STAFF RECOMMENDATION
1105 South Douglas Avenue
May 16, 2018

Application: New construction - addition

Description of Project: This application is for a rear addition which extends taller than the ridgeline of the existing house.

Figure 5: Arrow indicates location of proposed skylight.

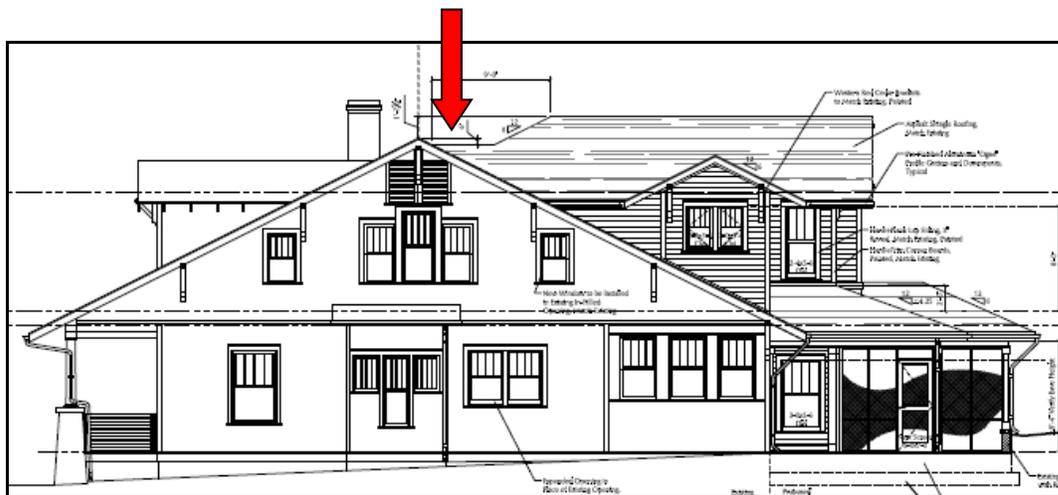
The applicant is proposing a skylight for the flat section of roof where the addition ties into the existing ridge. (See Figure 5.) This portion of roof sits six inches (6”) lower than the historic roofline. As long as the skylight is flat, and does not have a bubble-shaped profile, Staff finds that the skylight is appropriate, as it will not be visible. See ‘Design & Roof Form’ below for further analysis of the addition’s roof.

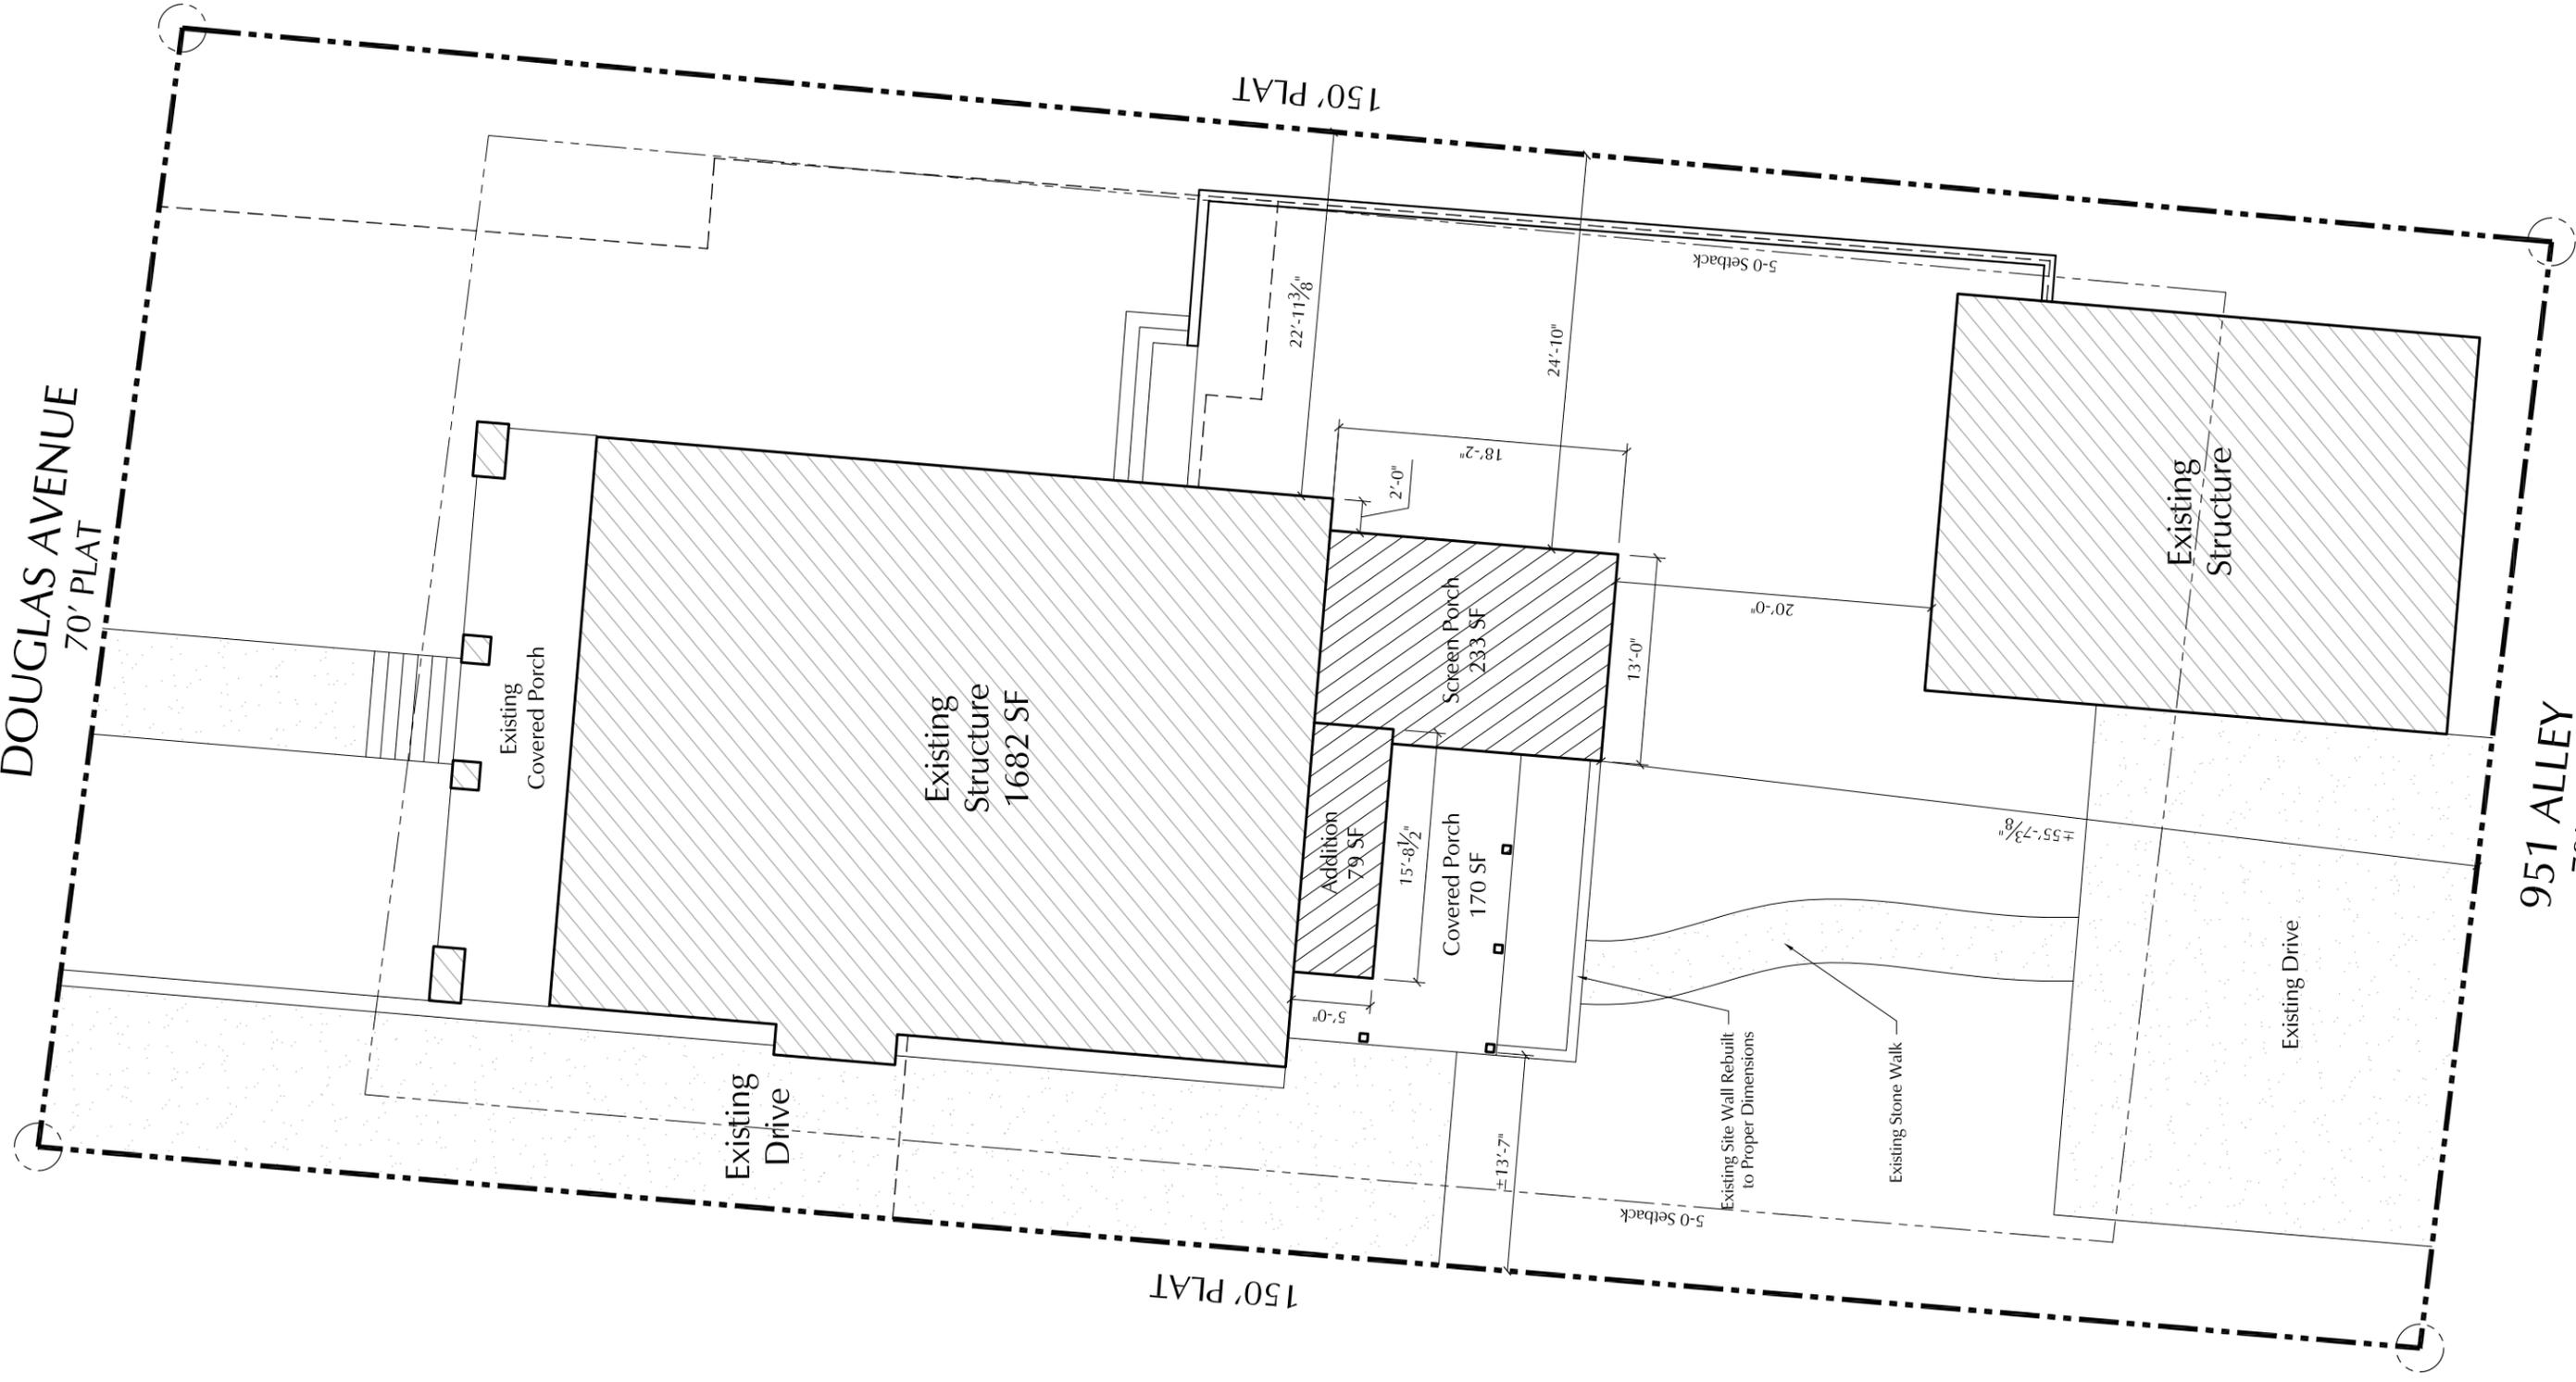
On the rear elevation, the existing rear-facing dormer will be removed to accommodate the addition of the master suite on the second floor. (See Figure 4.) The ground-level doors and windows will be removed as will a portion of the rear wall. Staff finds this work to be appropriate as it is occurring on a non-public façade.
